MEMO – REMOVAL OF WINTERGARDENS

RE:	PAGES	DATE
17155_300 City Rd, Southbank VIC	2	29/11/23
<i>TP Endorsement</i>		
FROM	TEL	EMAIL
Elenberg Fraser - Daniel Hazmy	(03) 9600 2260	d.hazmy@fraserandpartners.com.au
TO CC		
Ratio - William Bromhead		williamb@ratio.com.au
Ratio - Angela Mok		angela.mok@ratio.com.au

Typical 1 bed (Proposed)

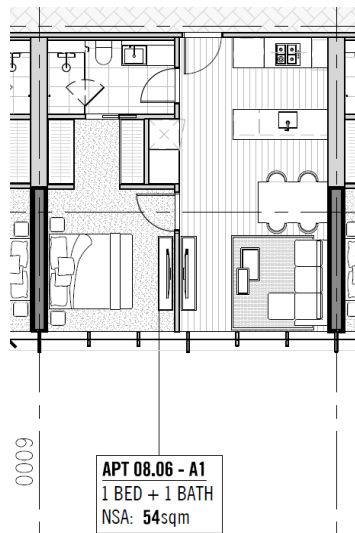
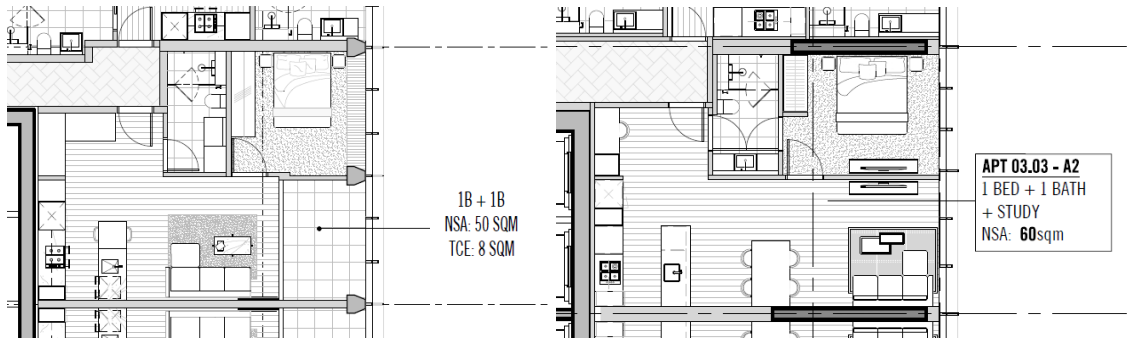
Improved internal layout with walk in robes with secondary entry to the bathroom accessed from the bedroom.
Additional storage cupboard provided adjacent to the laundry.

Typical 1 bed (Proposed)

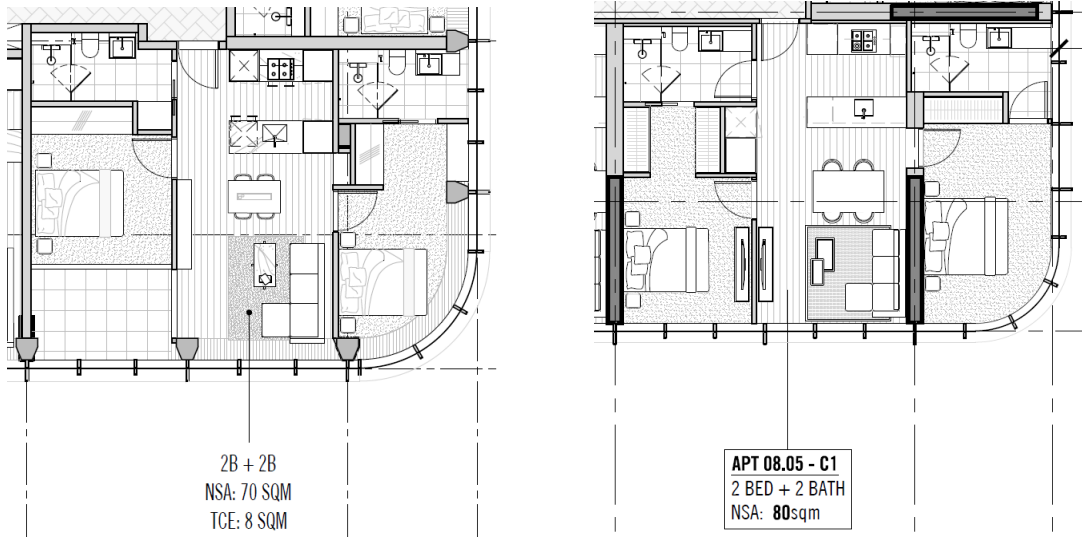
Improved internal layout with secondary entry to the bathroom accessed from the bedroom.

Additional area for dining now provided.

Study nook area now provided.

Improved internal layout with walk in robes with secondary entry to the bathroom accessed from inside the second bedroom.

Additional storage cupboard provided adjacent to the laundry.
